FLIGHT READINESS STATEMENT
STS-83/ET-84 AND STS-84/ET-85
EXTERNAL TANK PROJECT
PRE-FLIGHT REVIEW

Space Shuttle
External Tank

STS-83/ET-84 and STS-84/ET-85 Pre-Flight Review

Alternate Blowing Agent Foam Implementation

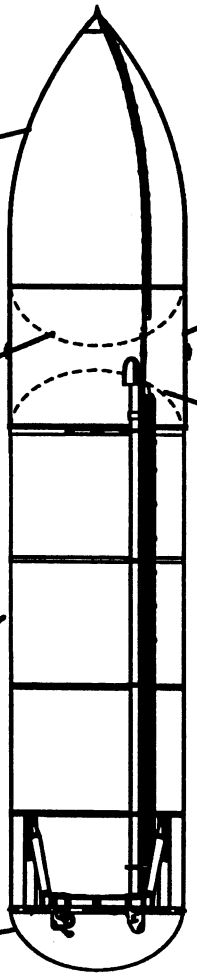
STS-84 (ET-85) and subs
- **NCFI 24-124 on LH2 tank sidewall**

STS-84 (ET-85) and subs
- **SS-1171 on LH2 tank forward dome**

Eliminate GSE Pressurization System

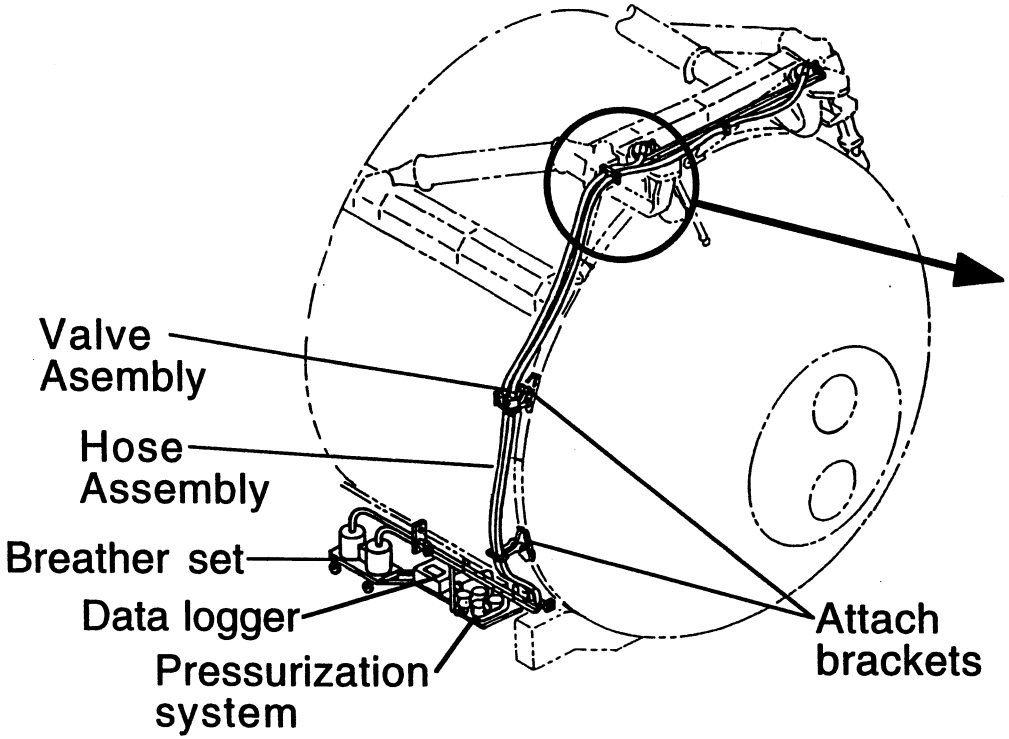
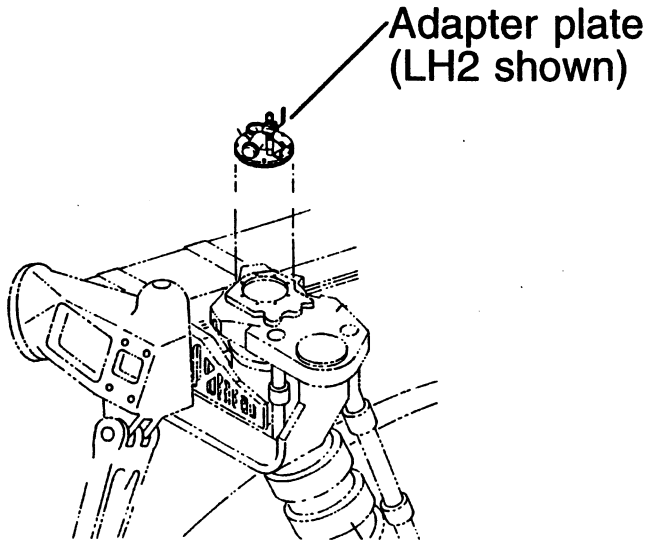
- Remove GSE desiccant breathers and pressurization system equipment prior to marine shipment for ET-84 and subs

- KSC process enhancement for Ship and Stack
  - Eliminates need for removal at KSC
- Desiccant breathers/pressurization system provided a contingency back-up system to prohibit contamination from entering the ET during marine shipment in the event of leakage
  - No use of desiccant breathers required since implementation
  - Barge personnel required to install desiccant
  - ETs 49, 51, 54 and subs shipped on unmanned NASA barge

- Hardware
  - No flight hardware impact
    - GSE pressurization system redesigned for MAF use
    - Remove GSE prior to ET roll out to NASA barge
- Documentation
  - Revised current MMC-ET-SE42 ET Long Term Storage requirement
    - Was: Verify ET pressure (6.0± 0.5 psig) at barge departure
    - Now: Verify ET pressure a maximum of 7 days prior to departure from dock
  - Revised Receiving Inspection, Storage and Checkout ICD to remove contingency pressurization ports

ET-85 LO2 Tank O-1 Weld Lack of Fusion

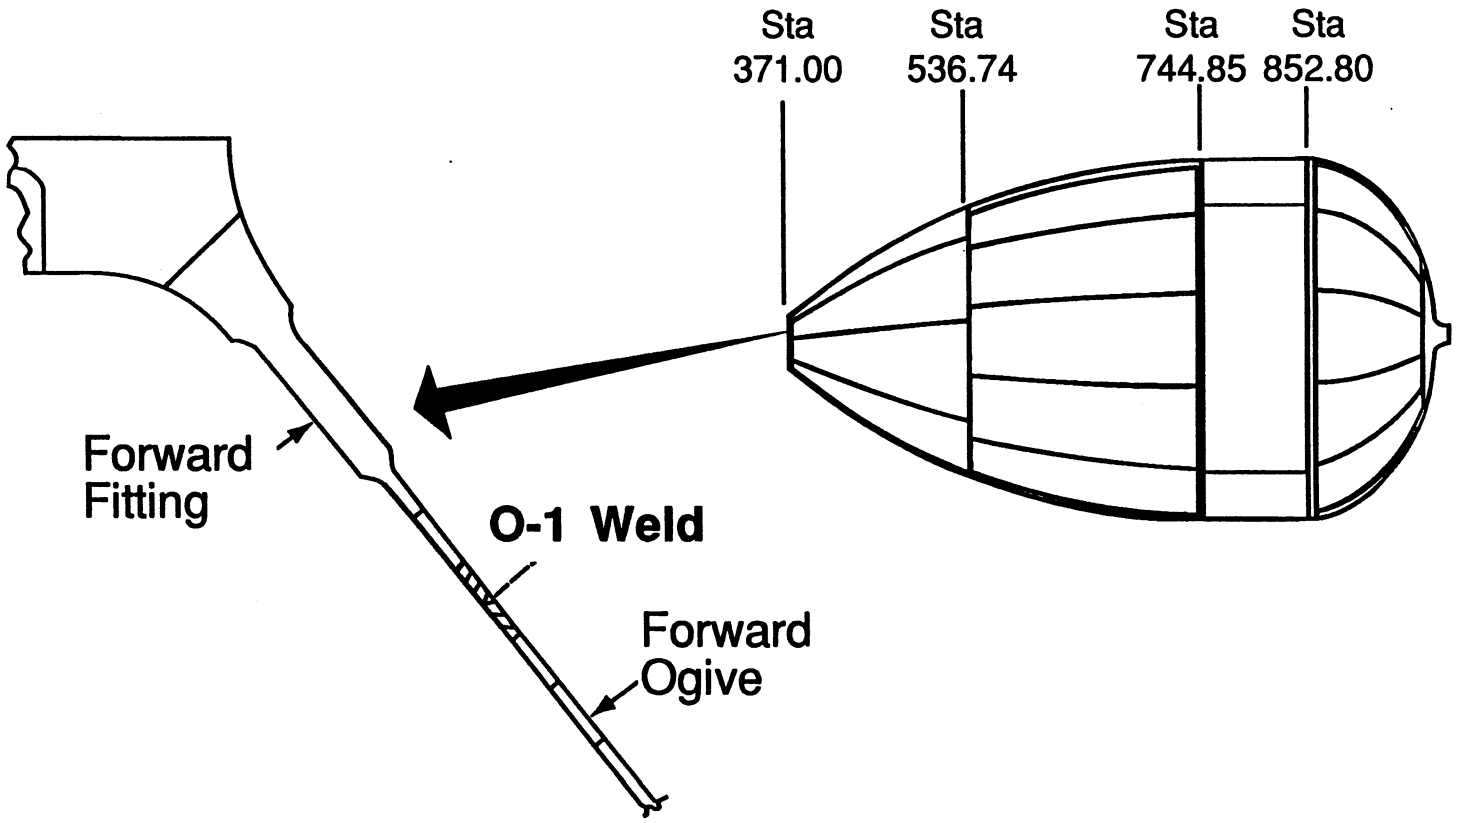
- 1.25 inch long lack of fusion in ET-85 O-1 weld detected by post proof test radiography

- Lack of fusion defect was result of heat repair accomplished for lack of fusion, porosity and oxide inclusion
  - Misinterpretation of pre proof test radiographic indication as alloy segregation

- Use as is

- No defects detected by visual and penetrant inspections
- Review of pre and post proof radiographic demonstrate no detectable flaw growth
- FS = 4.92, unchanged
- Weld significantly over-proofed for strength and fracture
- Fracture mechanics analysis
  - Conservative flaw size assumption
  - Fatigue life within database
    - Missions to leak = 72
    - Missions to burst = 1436
